ADDENDUM NO. 01

Millard Public Schools
Cottonwood Elementary – Secure Vestibule Addition
615 Piedmont Dr. Omaha, NE
BCDM Project No. 3008-11

October 14, 2026

SHEET S0-0

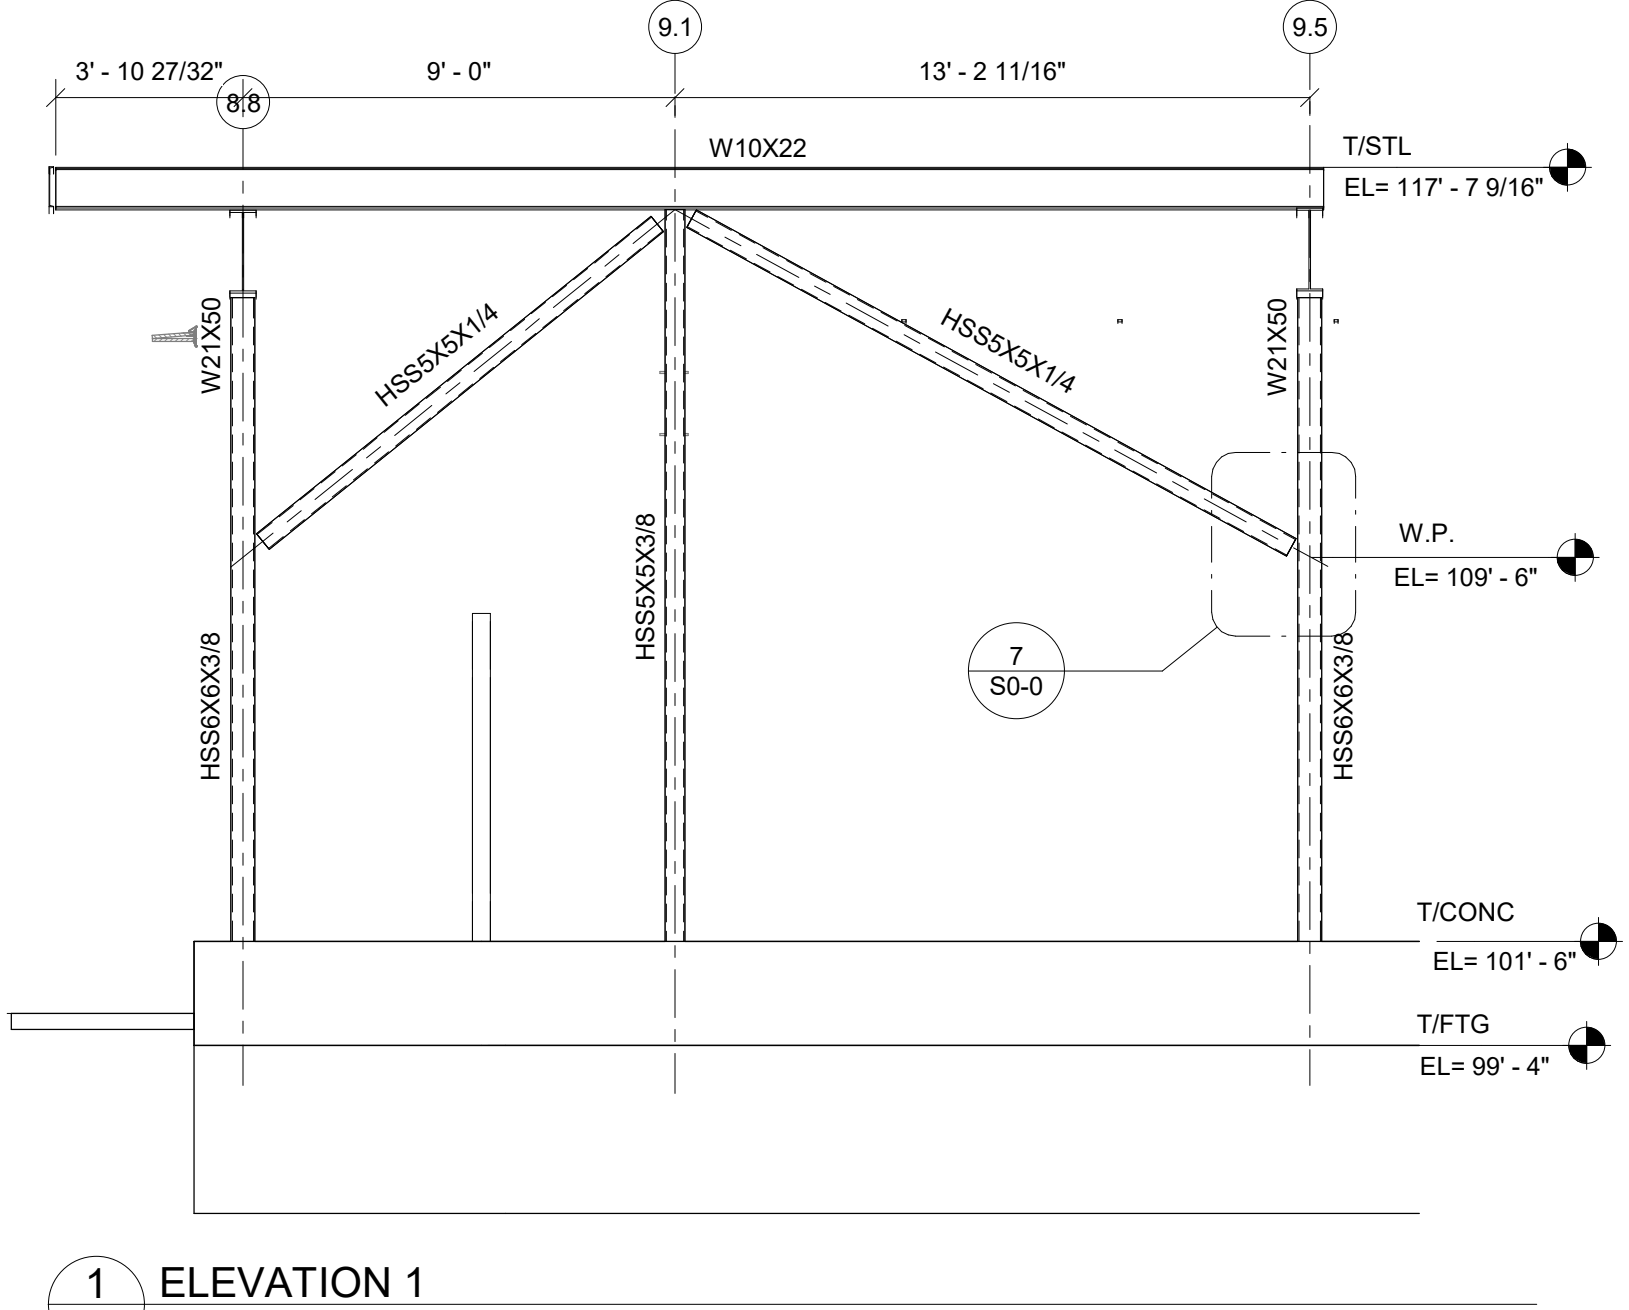
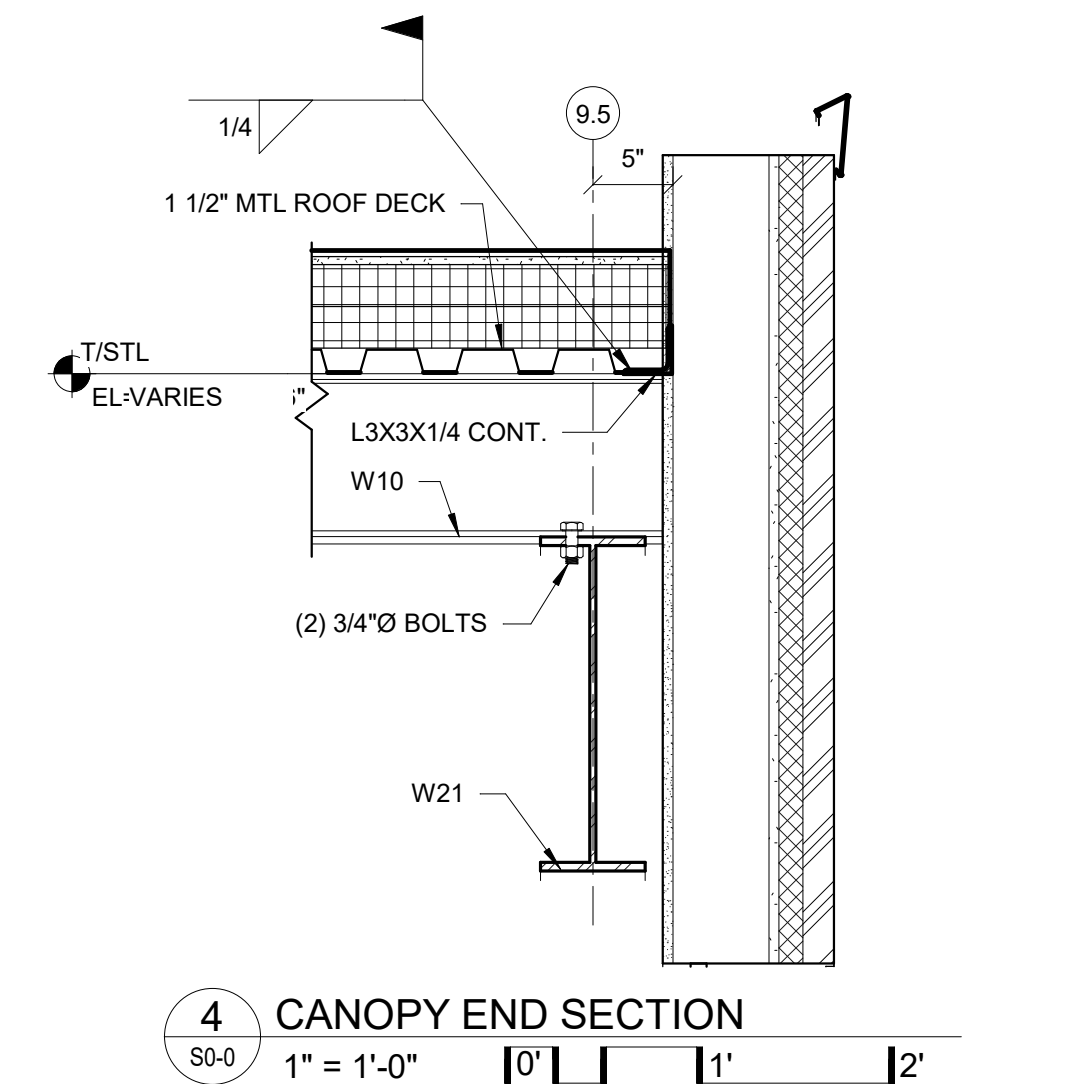
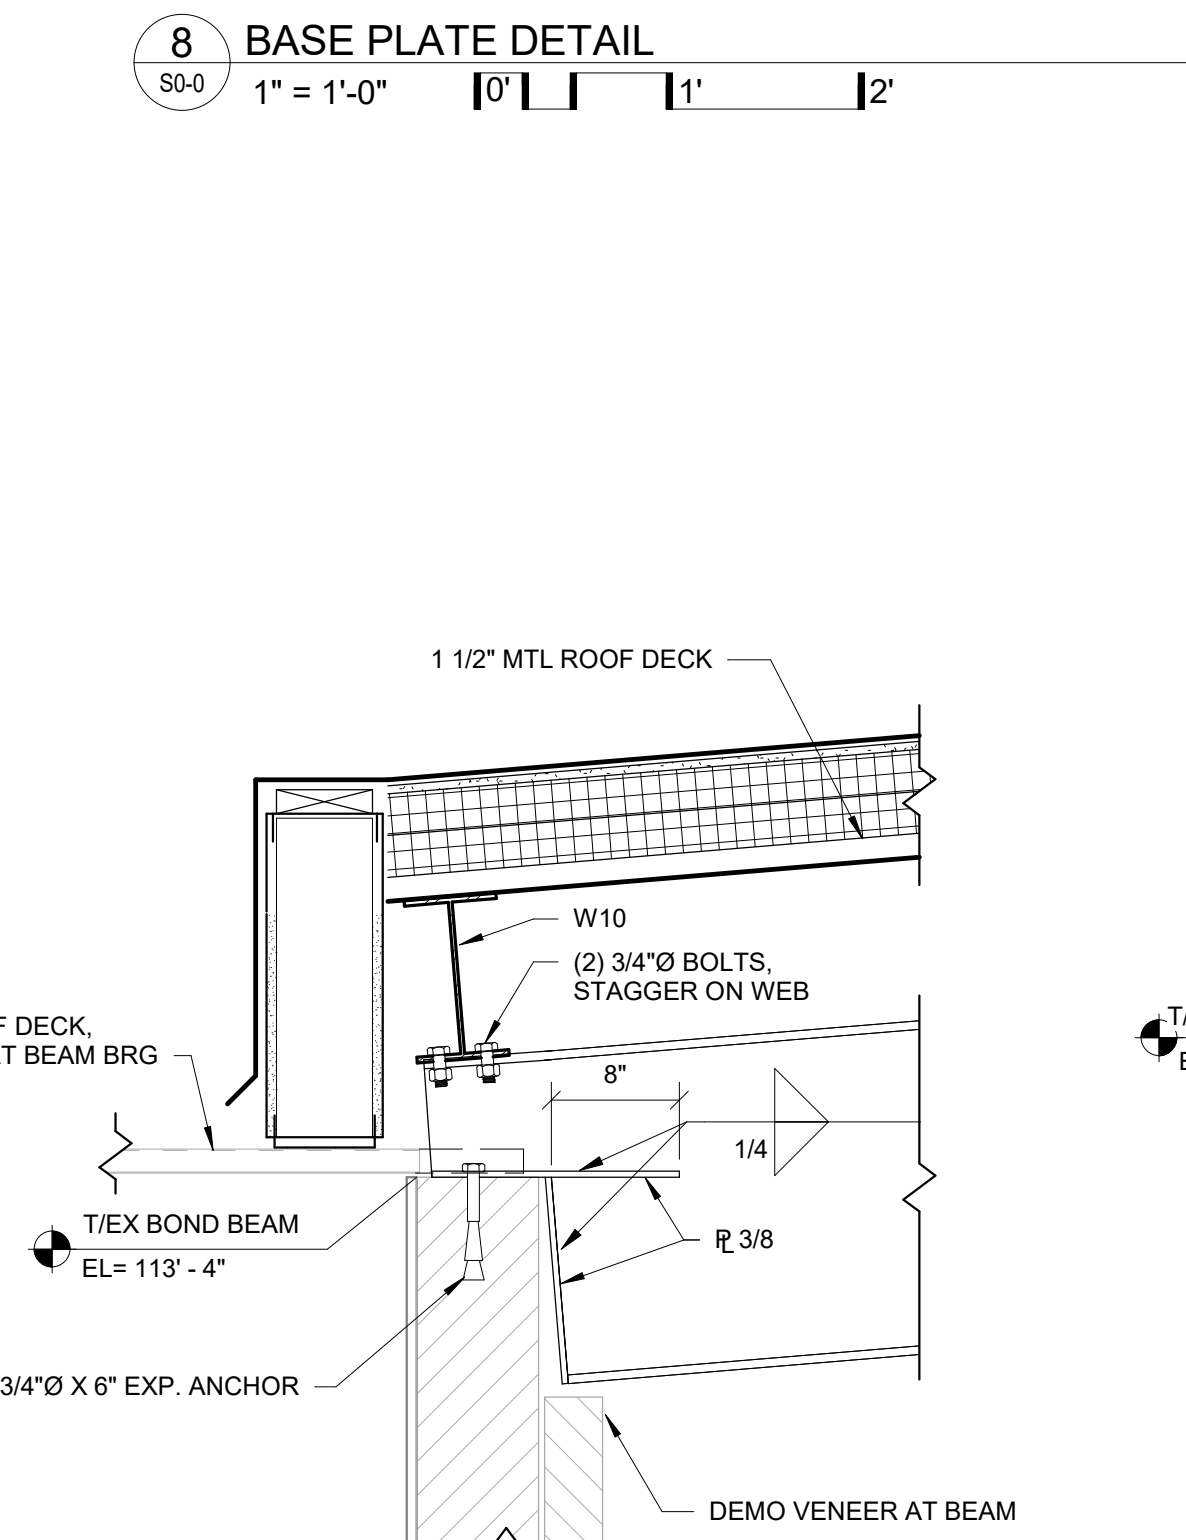
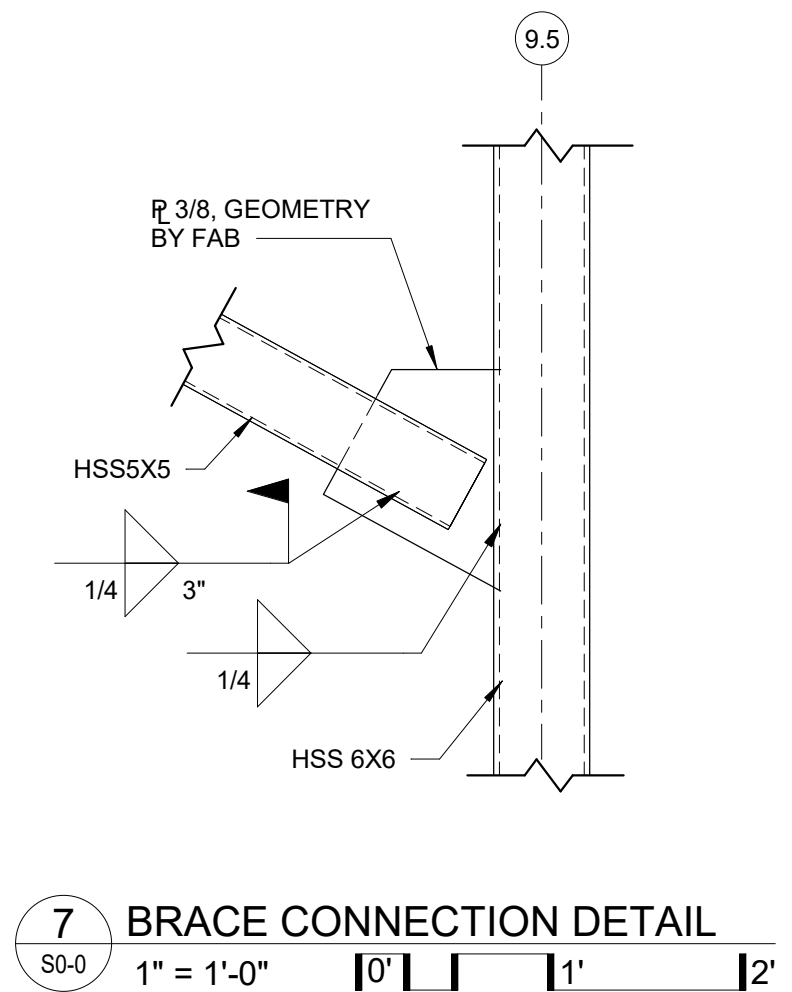
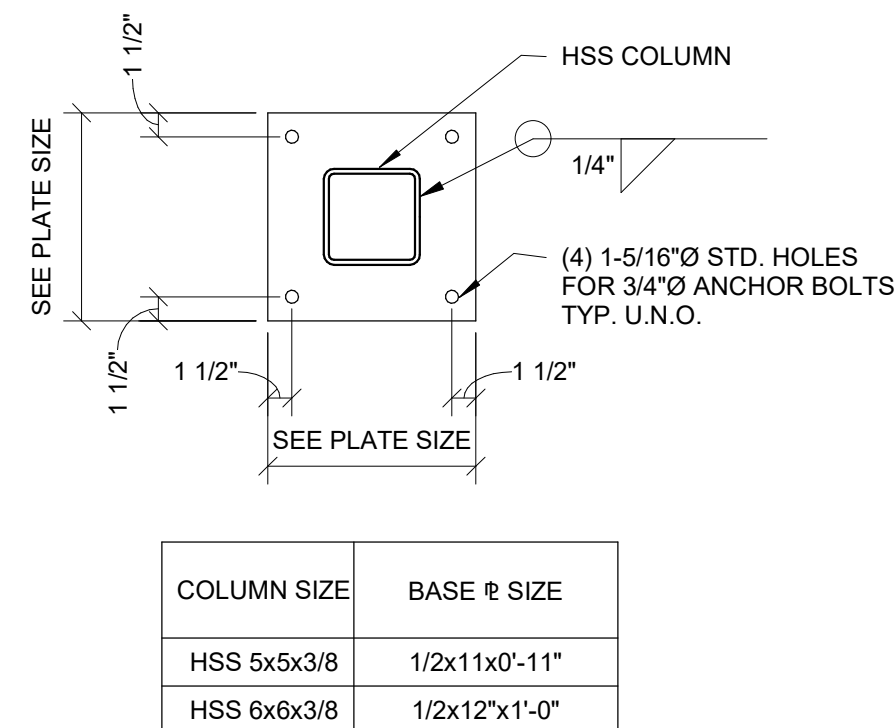
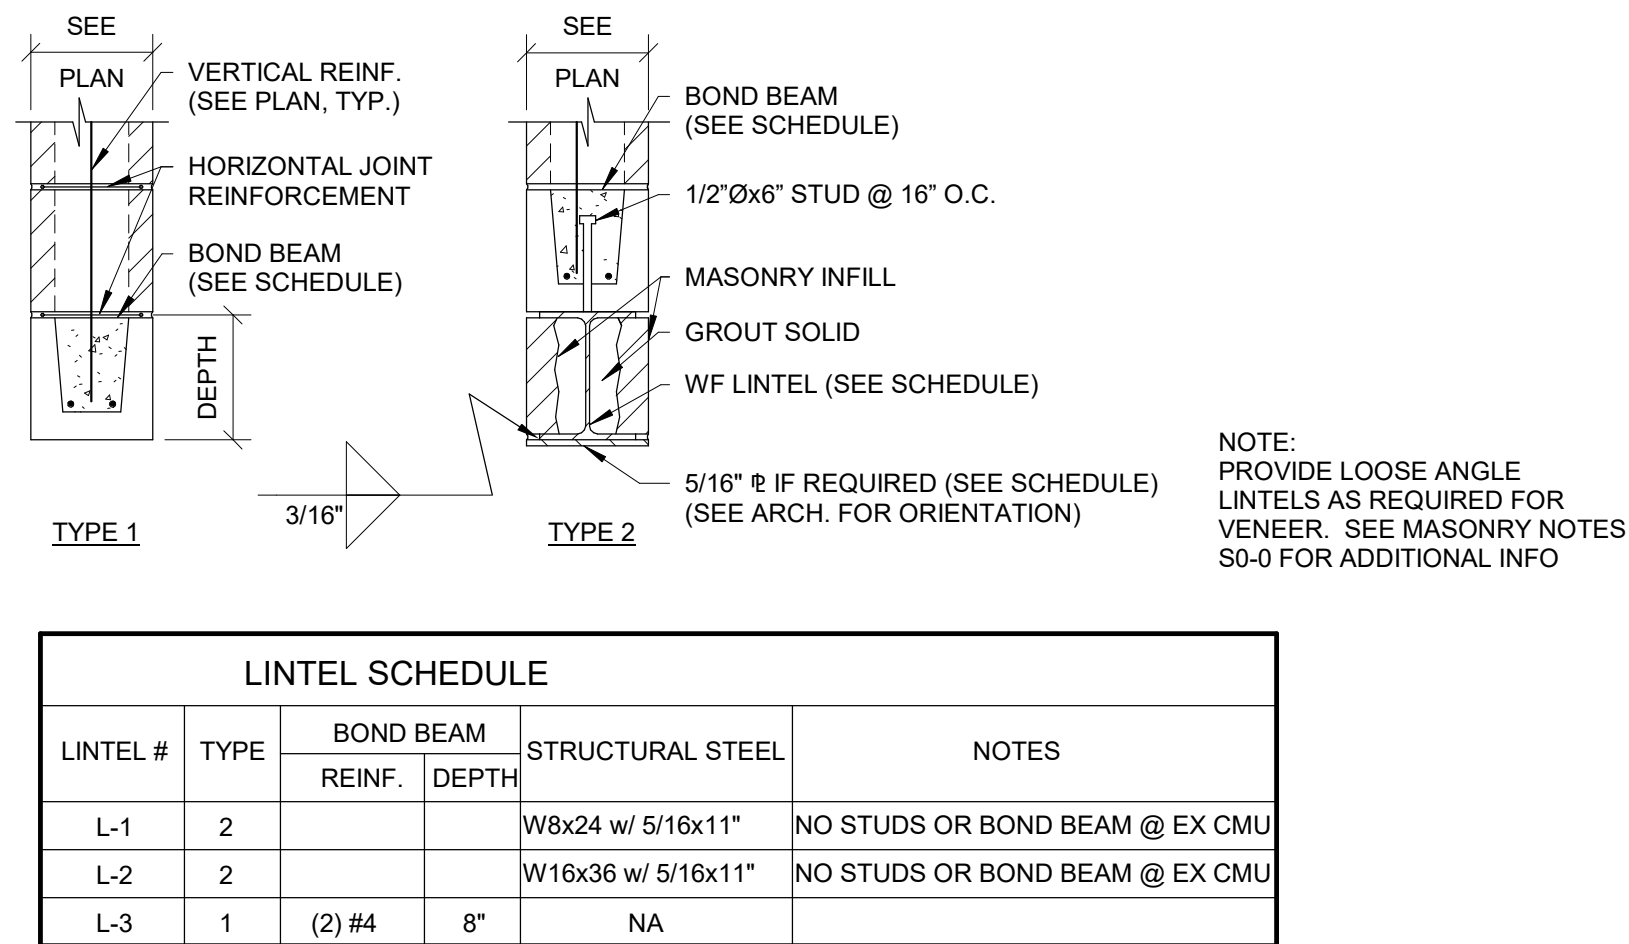
- a. Add additional wording to 2/AS0-0 as shown on the attached drawing.
